ANDERSON FARMS  
(This design subject to change)

Subject: Review of Traffic Impact Analysis for Proposed Anderson Farms  
Residential Development

**Plat of Anderson Farms  
Civil Plan Review  
October 17, 2005  
Jon R. Stack, P.E., City Engineer**

**Re: Response to File Number FPPUD05-003, Anderson Farm PUD  
Preliminary Submittal Review Comments**

**DOWNSTREAM PHOTOS AND NARRATIVE**

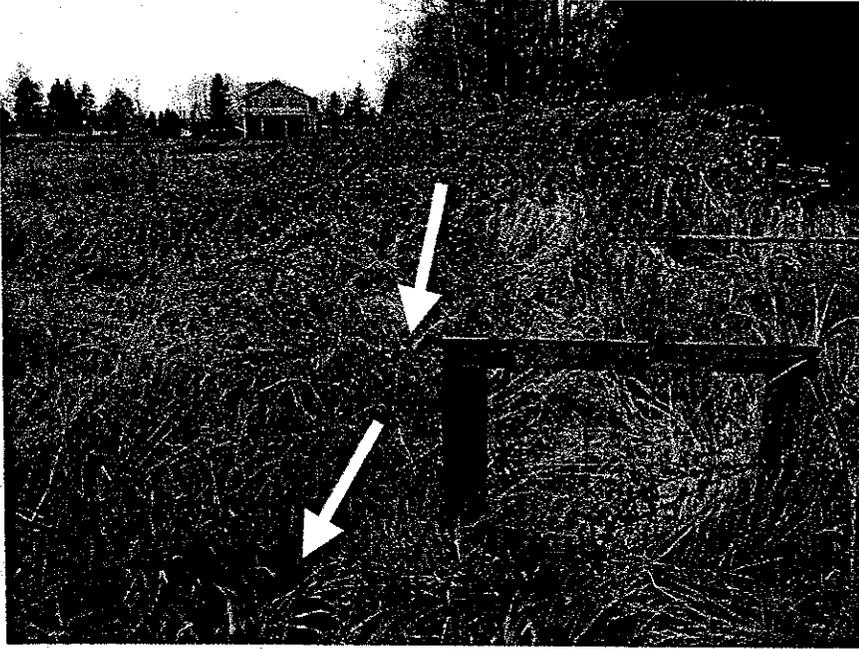
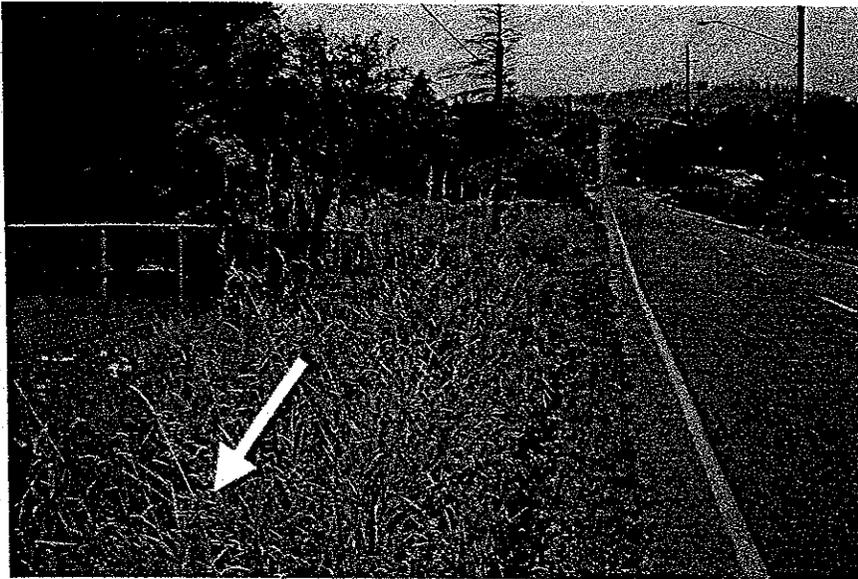
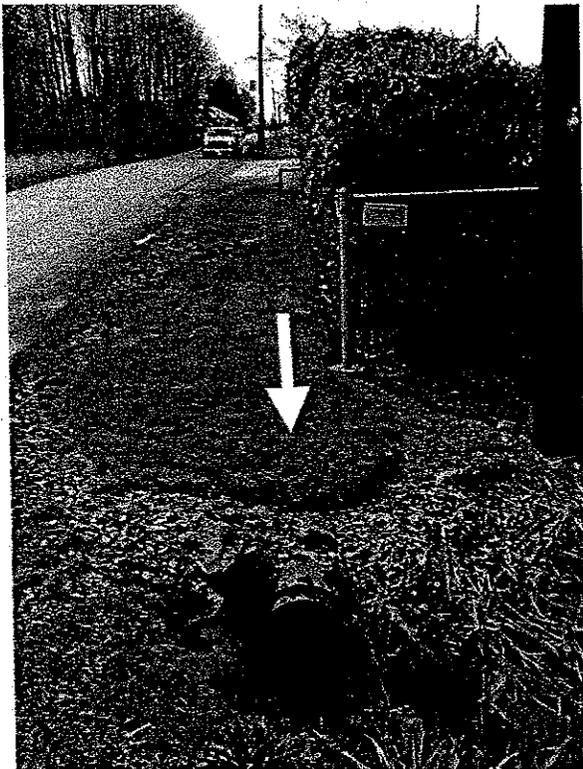
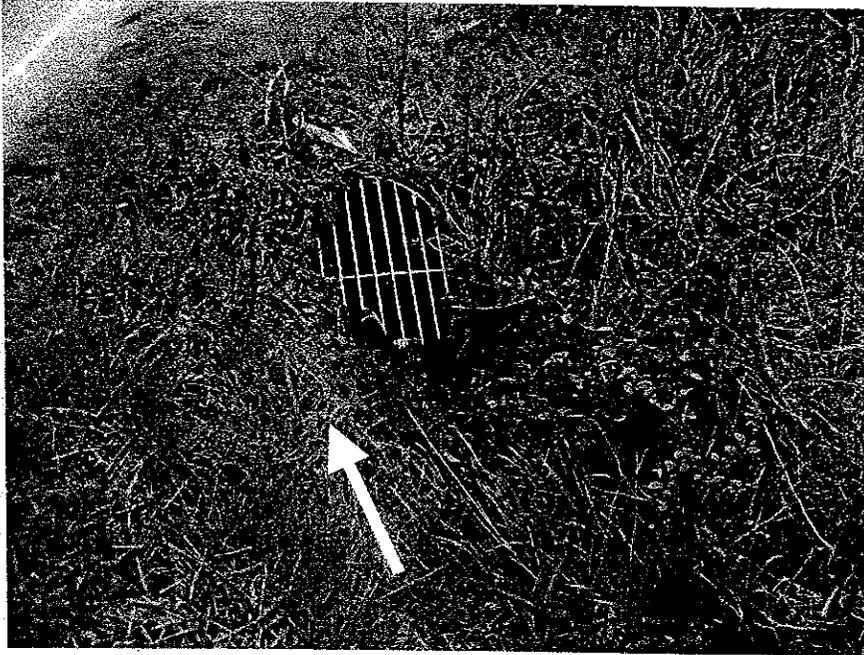
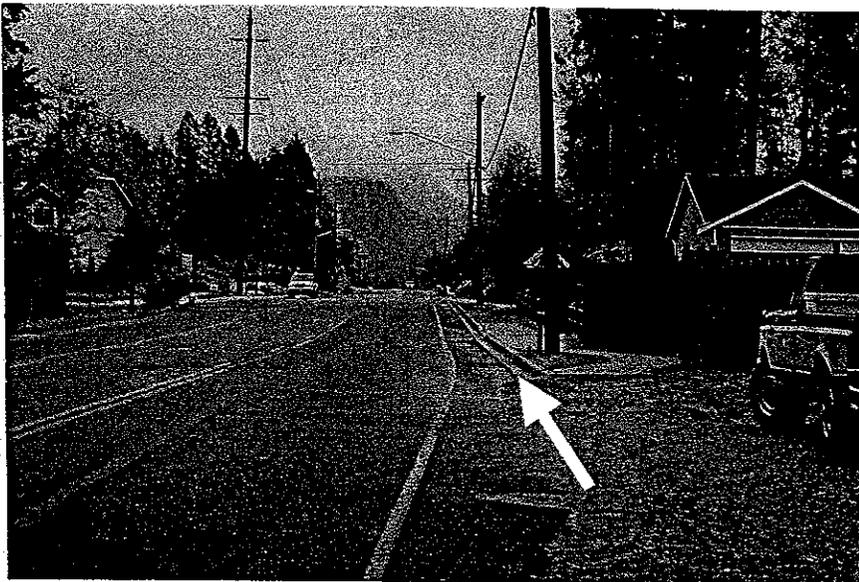
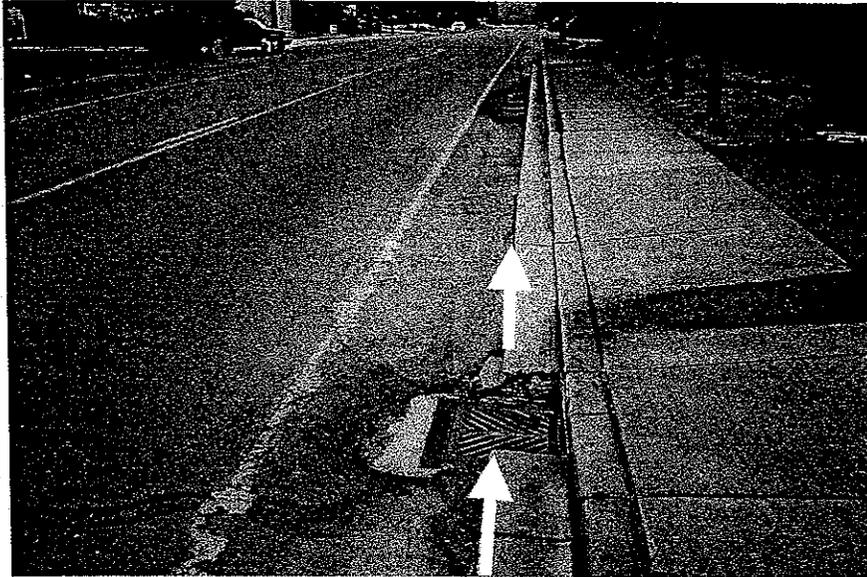
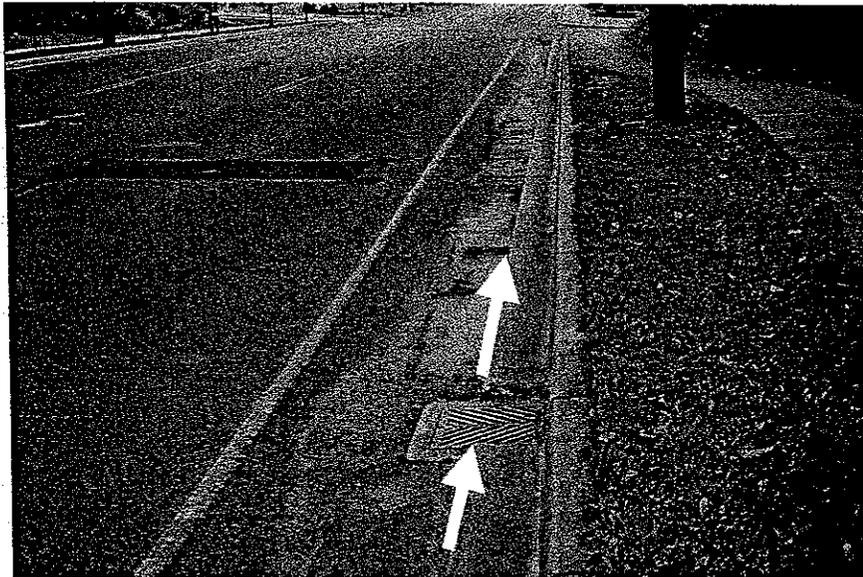
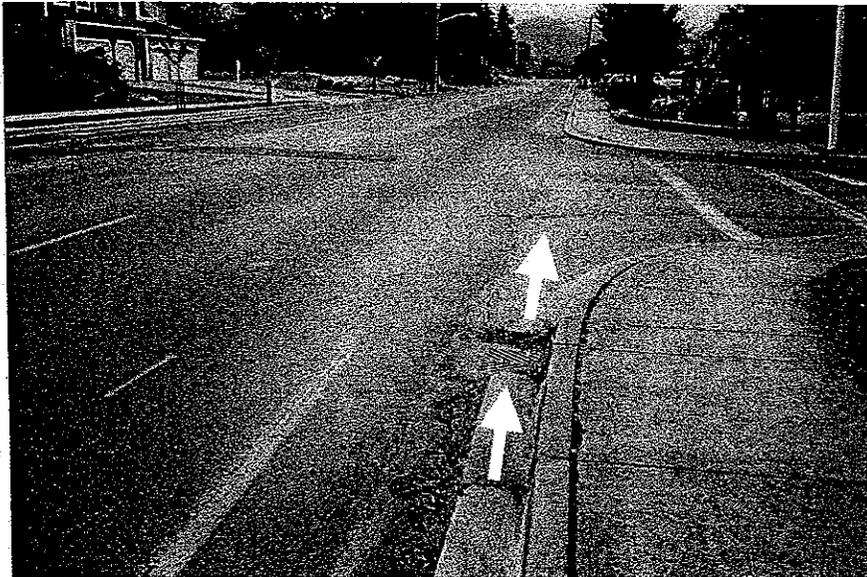
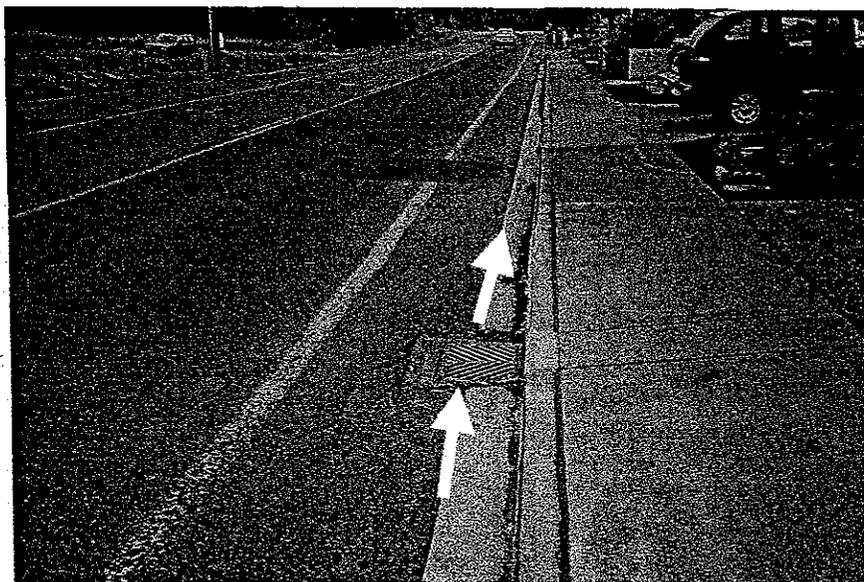
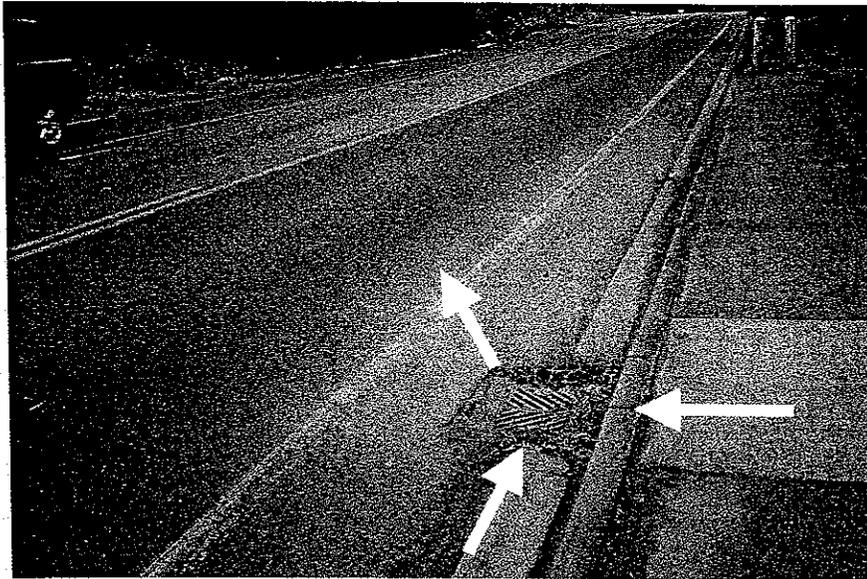
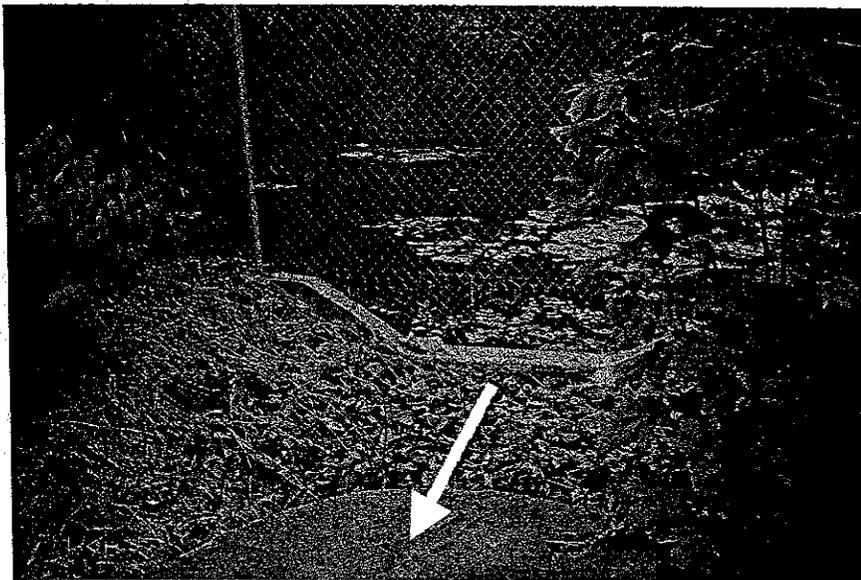
- 1) The storm drainage internal design appears adequate, however a down stream analysis of the drainage existing the site is required. (see page 3 of drainage report).**

Drainage ditches and a drainage pipe system provide drainage flow to the south along Sultan Basin road. (See downstream report).
